**RE: Winrock Town Center
Conceptual Grading & Drainage Plan
Engineer's Stamp Date: 6/17/25
Hydrology File: J19D058L
Case # HYDR-2025-00220**

TITLE: CONCEPTUAL GRADING PLAN

CONCEPTUAL GRADING & DRAINAGE PLAN

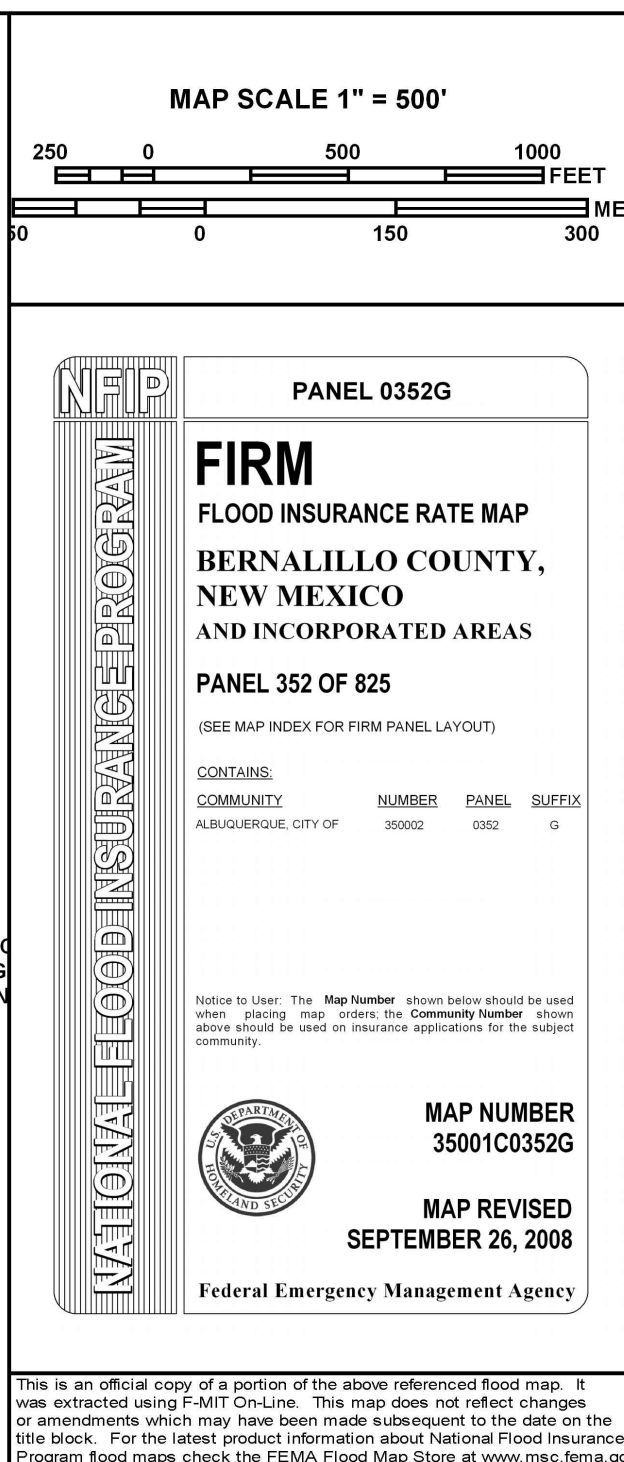
Based upon the information provided in your submittal received 06/18/2025, the Conceptual Grading & Drainage Plan is preliminary approved for action by the Development Facilitation Team (DFT) on Site Plan for Building Permit and for action by the Development Hearing Officer (DHO) on platting.

1. Please submit a more detailed Grading & Drainage Plan to Hydrology for review and approval. This digital (.pdf) is emailed to PLNDRS@cabq.gov along with the Drainage Transportation Information Sheet.
